Access Compliance Report Public Rights-of-Way (Curb Ramps)

Main Street: S_SELLAS_RD		Cross Street: SIENNA_PKWY		Location:	SE
ADA ID: RPRK211111134109	Ramp Type: Type 1 - Perpendicular	Initial Pass/Fail: Fail	Overall Compliance: No	Severity Score:	15
Codes/Mitigation Info/Possible Solution			Field Measurements/Component Compliance

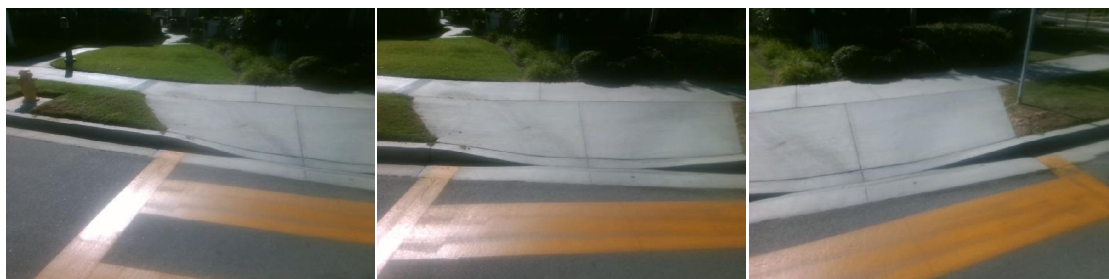
Compliance	Description	Data	Compliance	Description	Data
N/A	Ramp Length (in)	73	N/A	Flare Type LT	
Yes	Ramp Width (in)	48			N/A
No	Ramp Run Slope (%)	11.8	N/A	Flare Slope LT (%)	N/A
Yes	Ramp Cross Slope (%)	1.4	N/A	Flare Traversable LT	N/A
N/A	Landing Present	N/A	N/A	Flare Type RT	
N/A	Landing Length (in)	N/A			N/A
N/A	Landing Width (in)	N/A	N/A	Flare Slope RT (%)	N/A
N/A	Landing Run Slope (%)	N/A	N/A	Flare Traversable RT	N/A
N/A	Landing Cross Slope (%)	N/A	N/A	DWS Provided	N/A
N/A	Landing Movement Obstructed?	N/A	N/A	DWS Contrast	N/A
	Landing Movement Type	N/A	N/A	DWS Length (in)	N/A
N/A	Landing Shared	N/A	N/A	DWS Full Width	N/A
N/A	Clear Space	N/A	N/A	DWS Offset Left (in)	N/A
N/A	Clear Space To Crosswalk (in)	N/A	N/A	DWS Offset Right (in)	N/A
N/A	Marked Crosswalk 1	Yes	N/A	Marked Crosswalk 2	N/A
	Crossing 1 Direction	NE		Crossing 2 Direction	N/A
	Marked Crosswalk 1 Width (in)	144		Marked Crosswalk 2 Width (in)	N/A

Remove & Replace Entire Ramp.

R304.2.2, R204.3, STD 1115
